City of Portland, Maine - Building or Use Permit Application
 389 Congress Street, 04101 Tel: (207) 874-8703, Fax: (207) 874-8716

Permit No: 01-0614UN Issue Date: 6 2001 CBL: 339 L038001

BUILDING PERMIT REPORT

REASON FOR PERMIT: 8'x12' shed

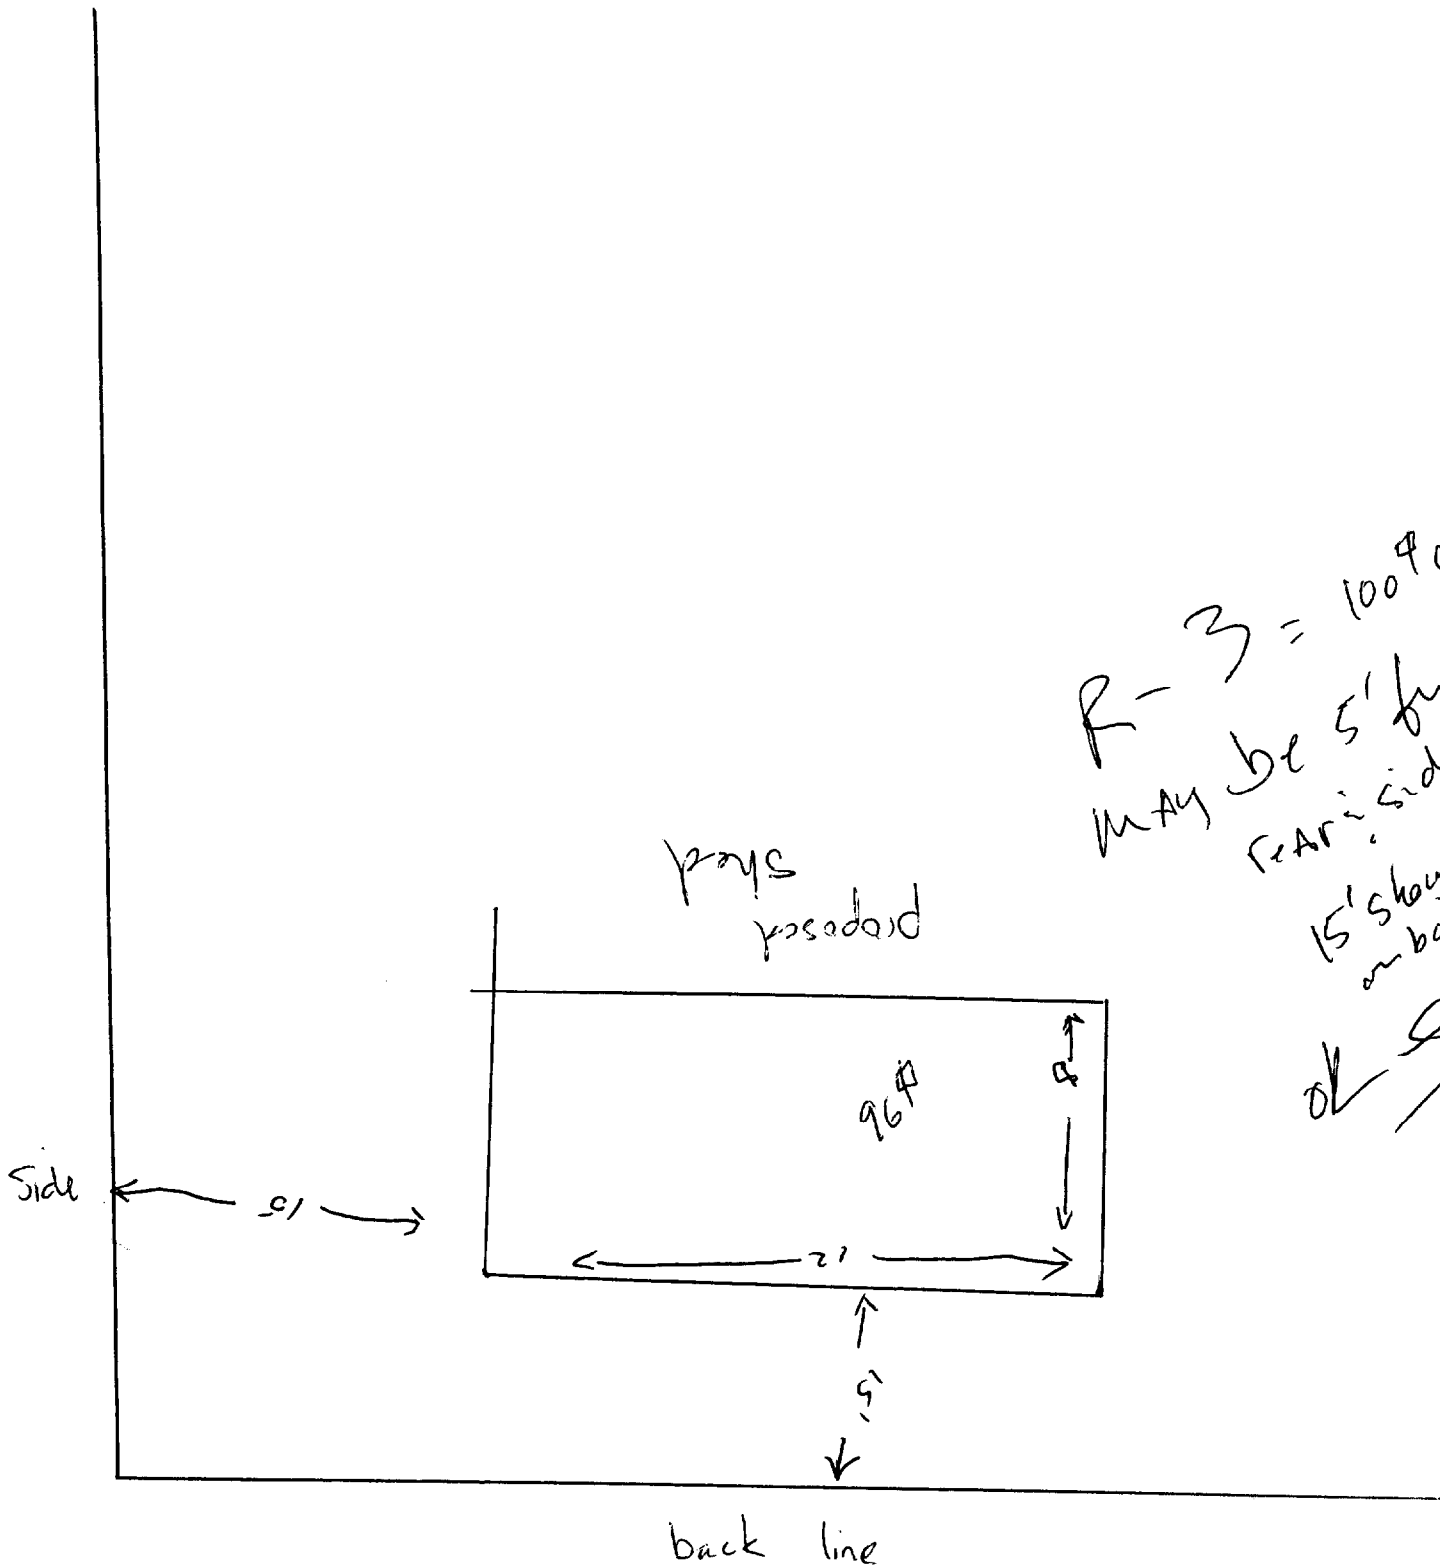
38. *Before placing shed, call Inspection Services For setback inspection.*
